Mr. John F. O'Leary, Director Directorate of Licensing United States Atomic Energy Commission Washington, DC 20545 Re: Docket No 50-155 License No DPR-6 Proposed Tech Specification Change 33

Request for Change to the Technical Specifications

Change No 33

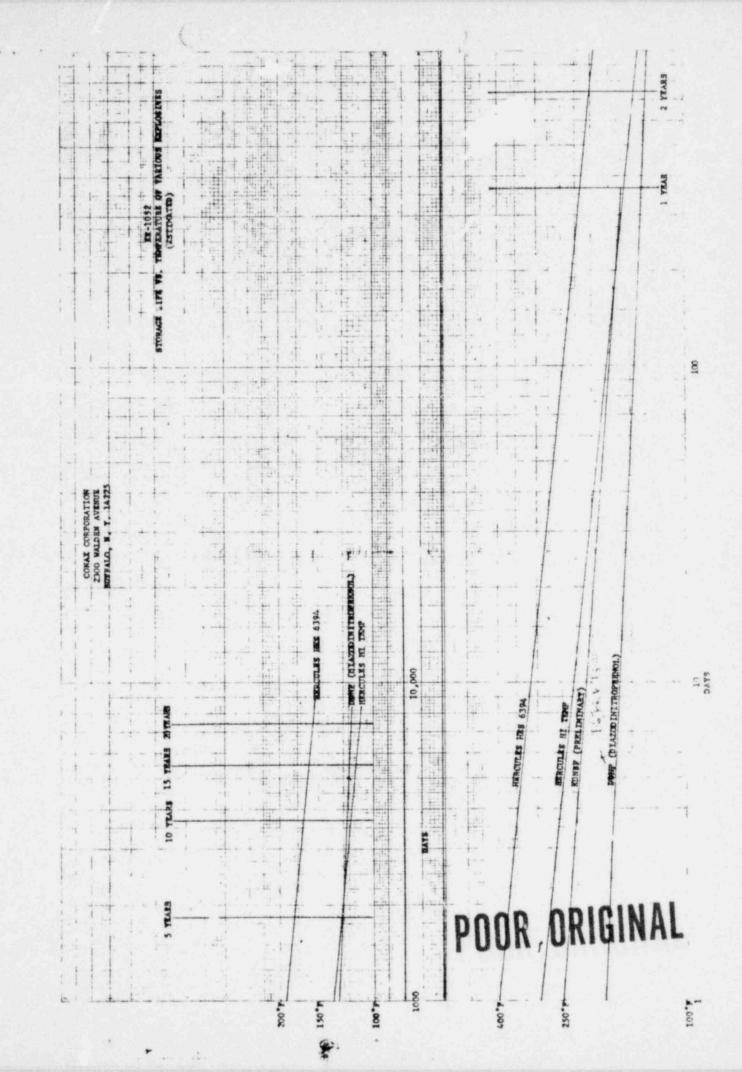
The life of the primers is conservatively based on the attached chart provided by the Conan Corporation. The values on this chart were developed, based on short life span testing of primers, and extrapolated to predict lower temperature - longer life relationships. A temperature monitoring program is in progress at Big Rock Point to determine the precise environmental temperatures that the primers experience. Current results show that the primers in the equalizing line experience a temperature of about 101°F while the warmest of the other five squib valves experiences a temperature of about 95°F.
